PETITION FOR SPECIAL HEARING
TO THE ZONING COMMISSIONER OF BALTIMORE COUNTY: 90-250-SPHA

Petition for Special Hearing and Zoning Variance
CASE NUMBER: 90-250-SPHA
W/S of Riverside Avenue, 1,450' NW c/l of Bay Avenue
1110 E. Riverside Avenue
15th Election District - 5th Councilmanic
Petitioner(s): Charles E. Myers, et ux
HEARING: WEDNESDAY, DECEMBER 20, 1989 at 9:30 a.m.

RE: Item No.: 109 - Case No. 90-250-SPHA-Special Hearing and Zoning Variance

BALTIMORE COUNTY ZONING PLANS ADVISORY COMMITTEE

PROJECT: AMENDED SITE PLAN
SCALE: 1" = 50'
DATE: MAY 11, 1989
DWG. BY: CAMPBELL

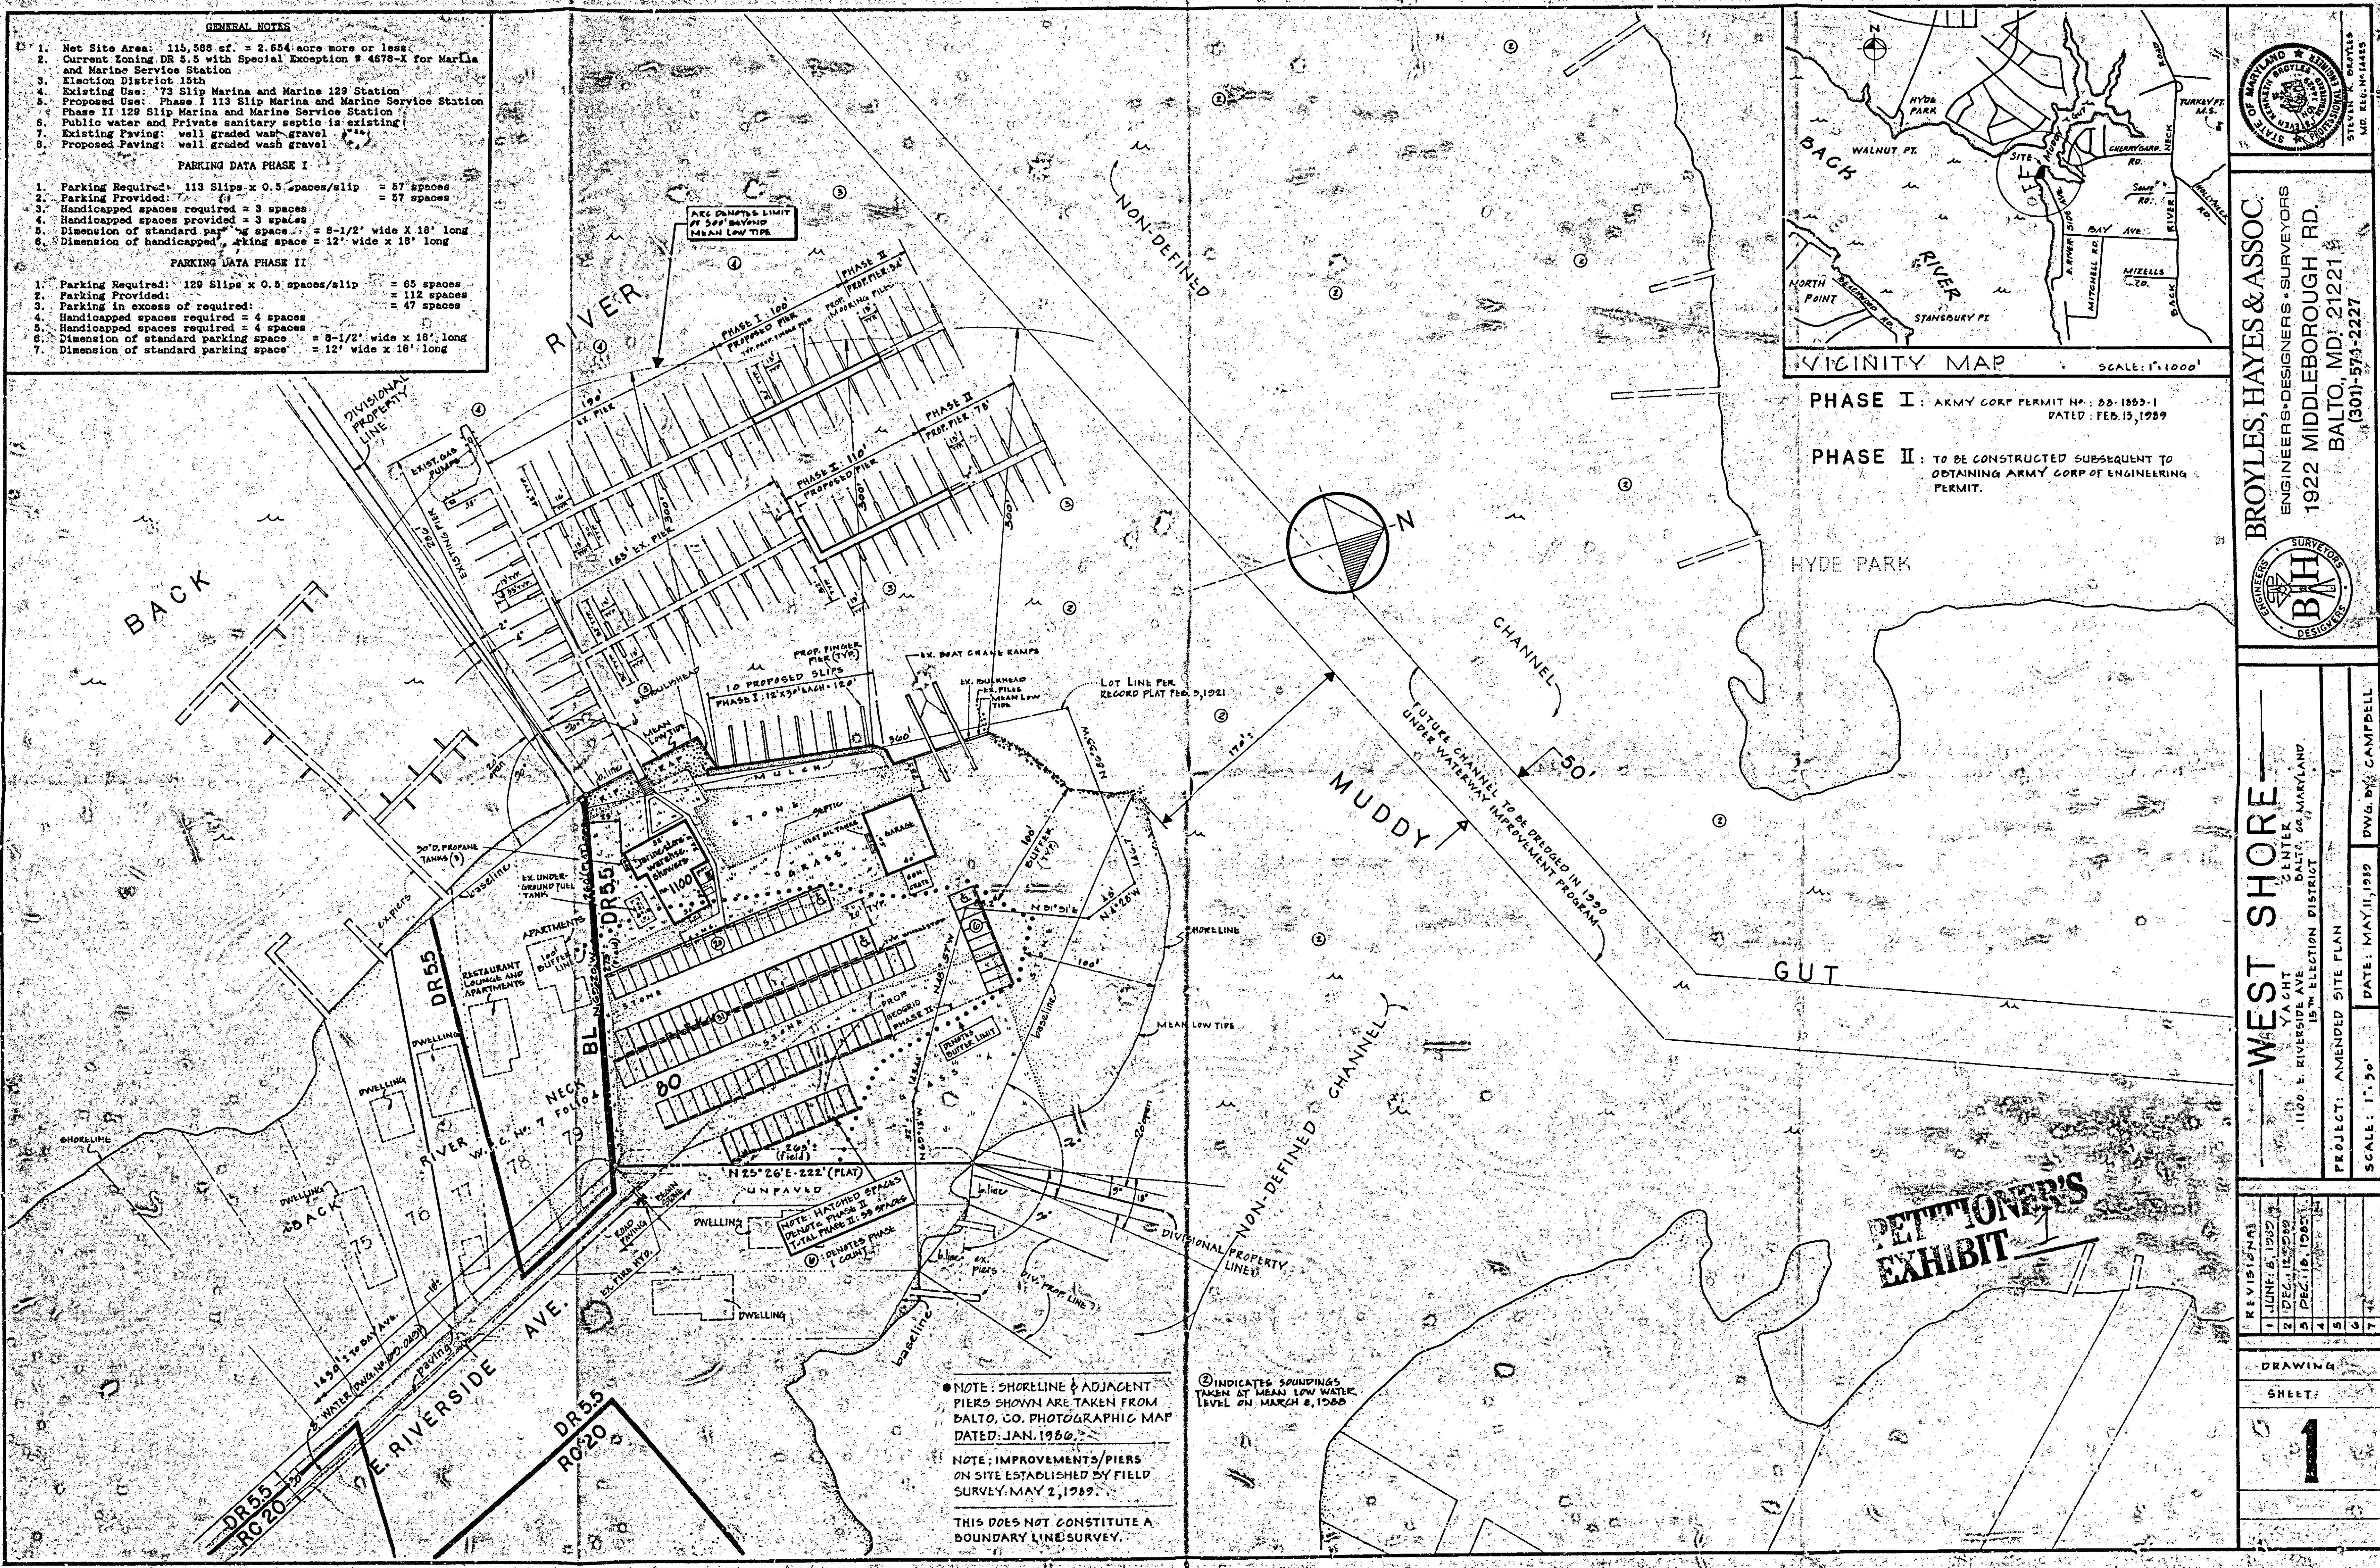
The Petitioner requests a variance to build beyond mean low tide parking in the buffer area adjacent to the muddy gut should be implemented.

- Should phase II be approved, the existing stone area which is indicated on the plan should be restored to its natural state.
- Wheelstops or some other means of preventing vehicles from parking in the buffer area adjacent to the muddy gut should be implemented.
- Prior to any action on this plan, measurements of the channel should be provided by the Petitioner to determine if an actual hardship exists.

PROJECT: AMENDED SITE PLAN
SCALE: 1" = 50'
DATE: MAY 11, 1989
DWG BY: CAMPBELL

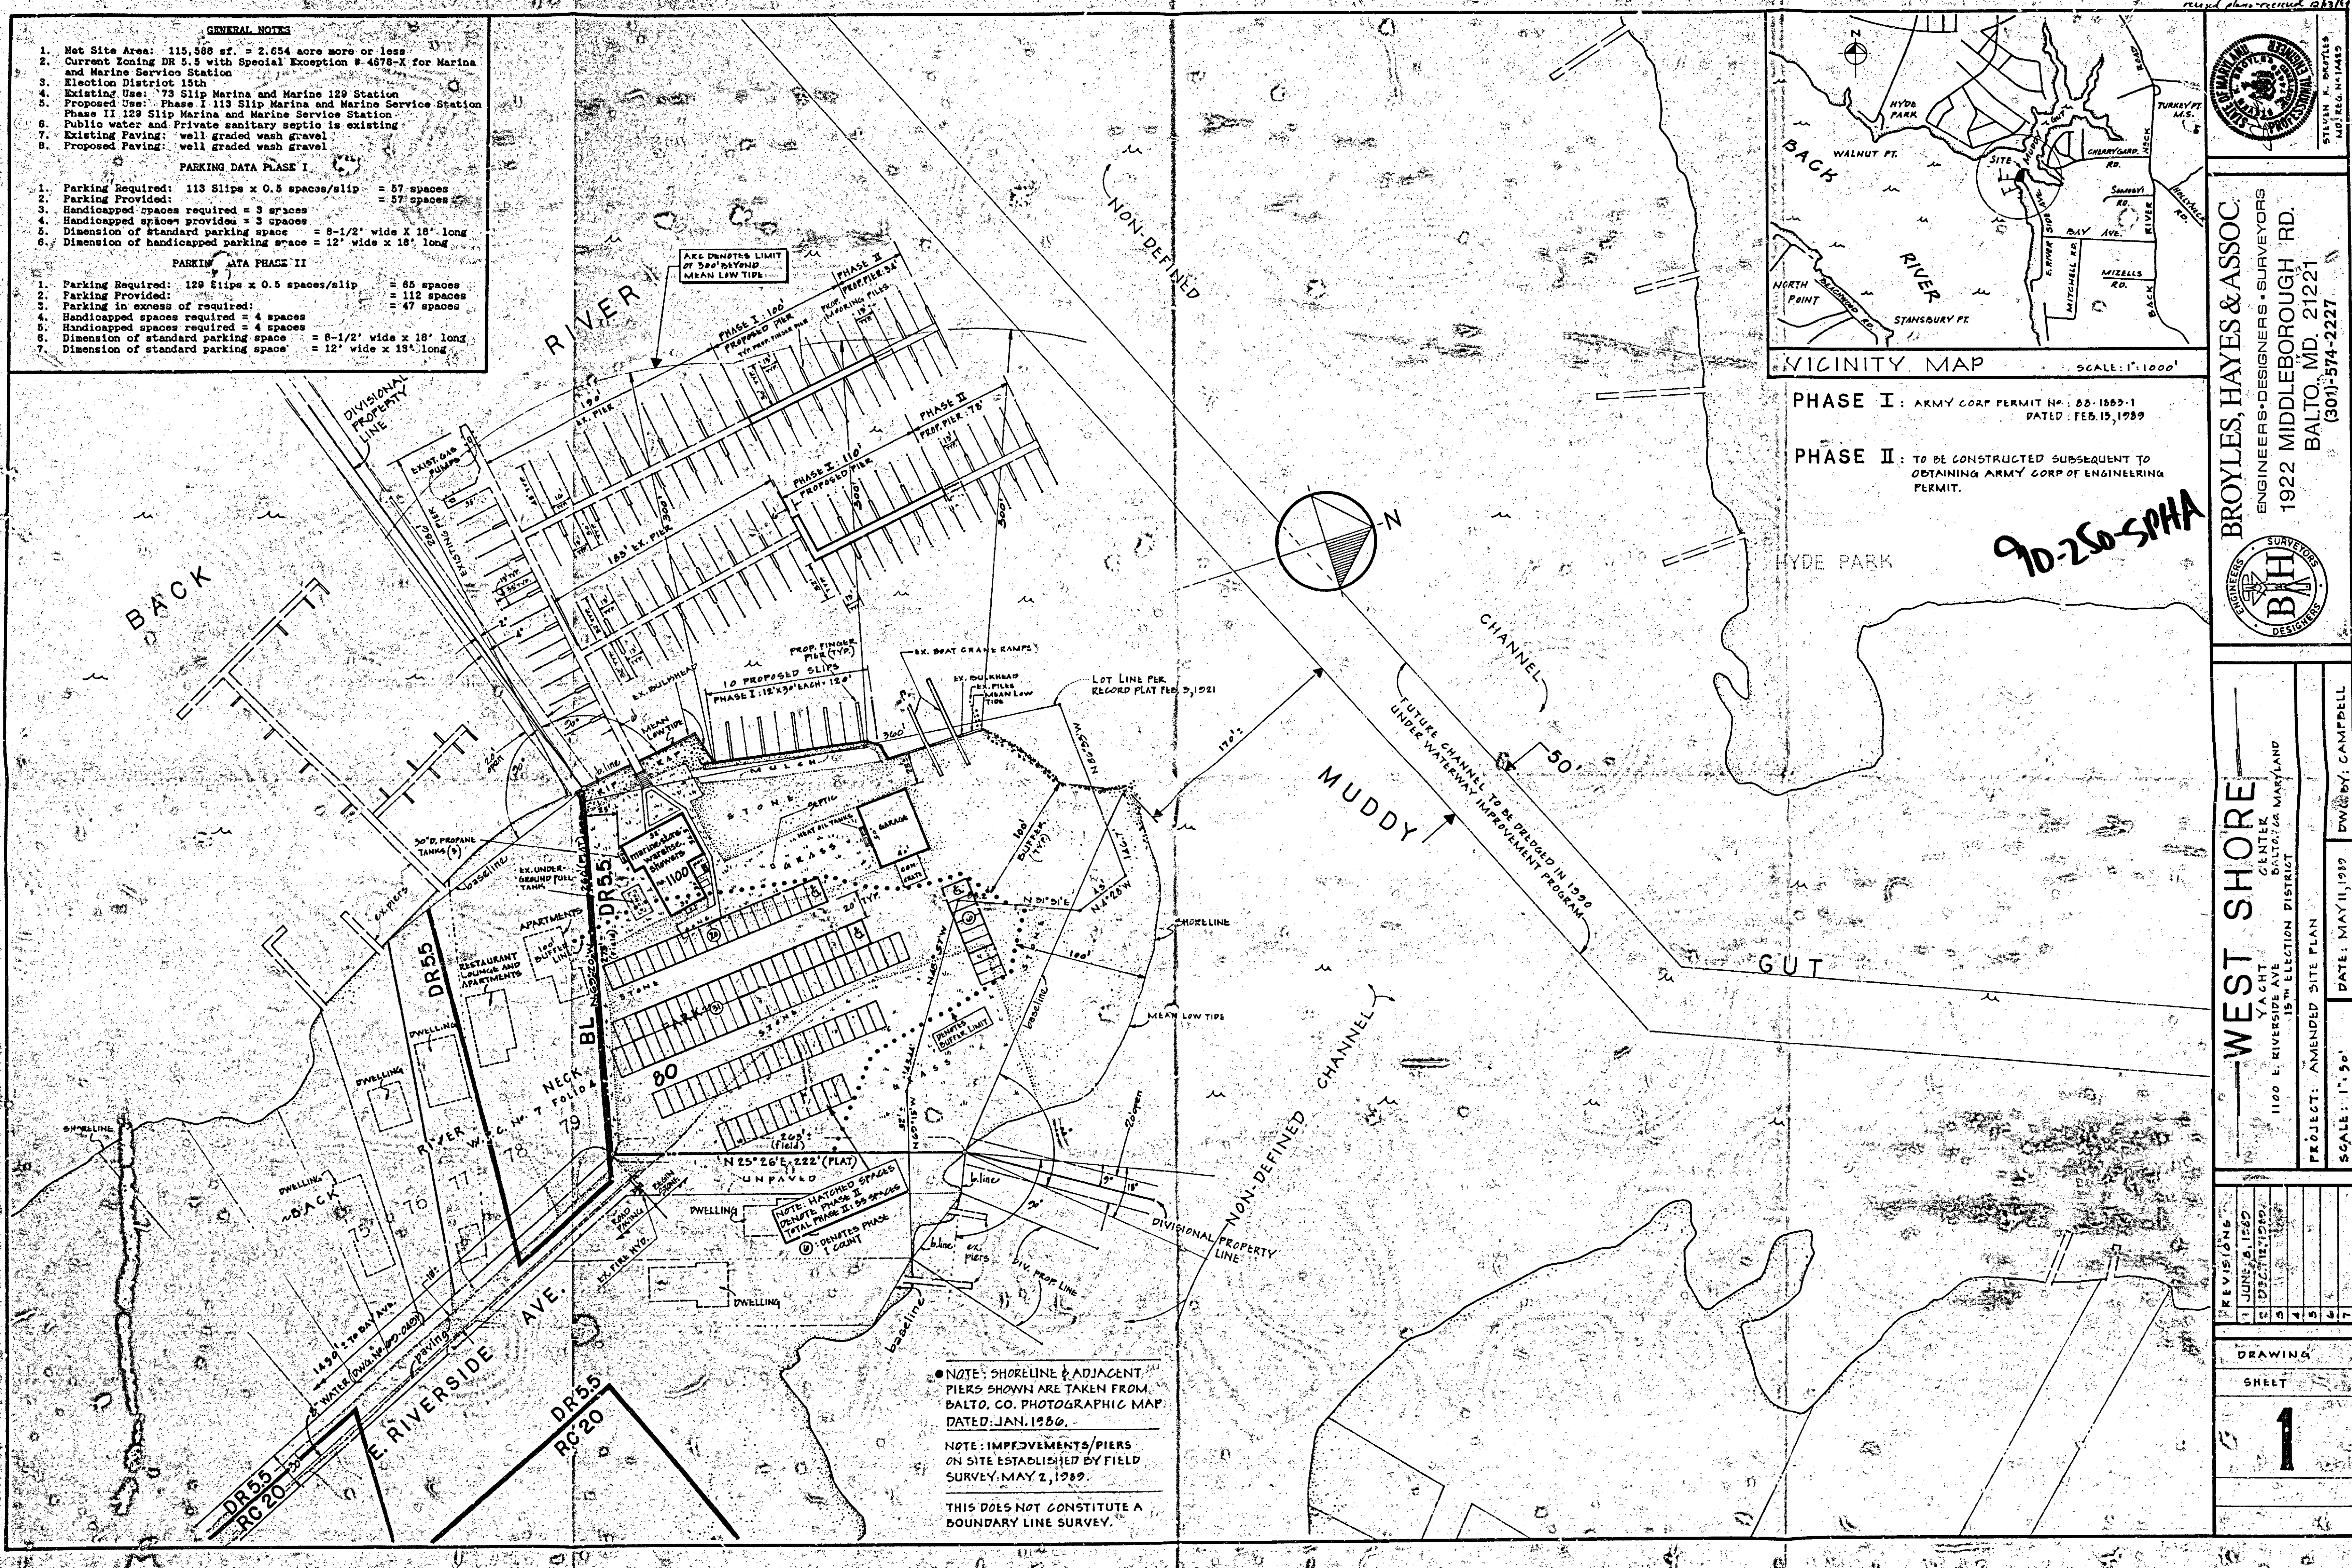
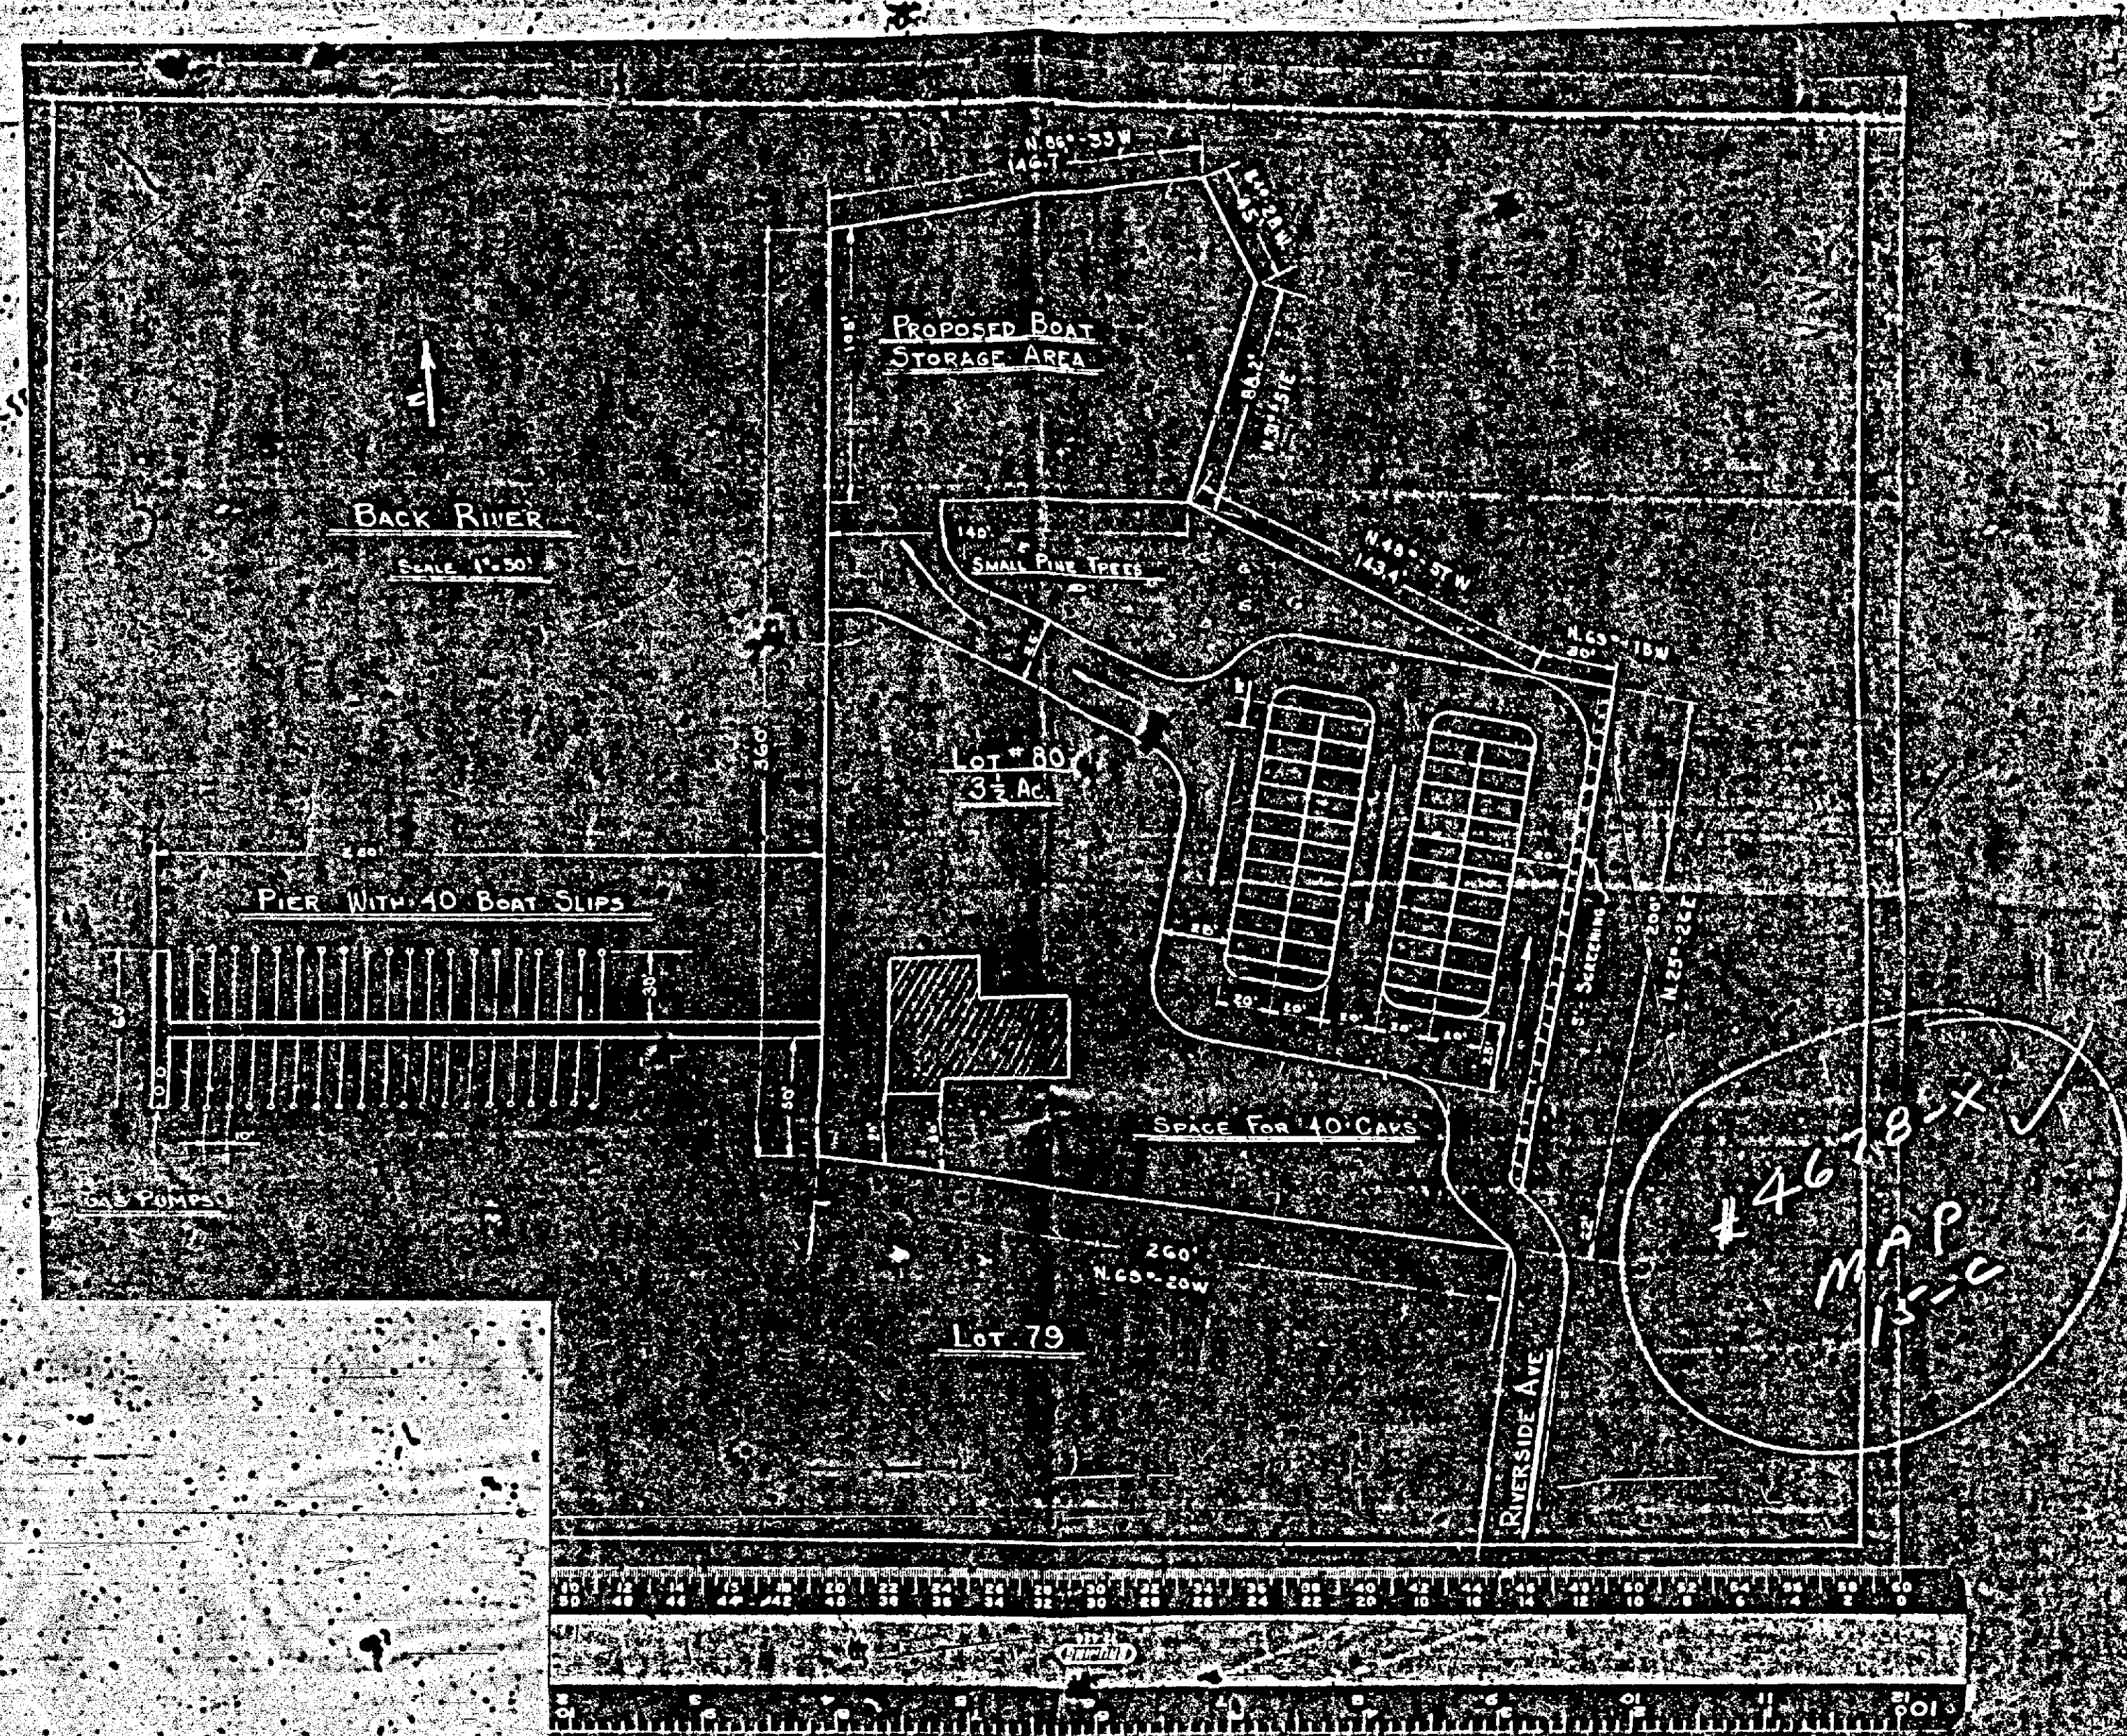
The general notes on the plan shows an expansion of 96 boat slips for this site and the plan itself shows an expansion of 106 slips. For the purposes of this review, I am assuming the 106 number is correct.

The proposed 106 slip expansion can be expected to generate approximately 318 additional on week days, 339 additional trips on Saturdays, and 837 additional trips on Sundays.

The roadways in the area are intended for low volume residential use. The proposed expansion of this marina will cause a major increase in traffic and congestion can be expected.
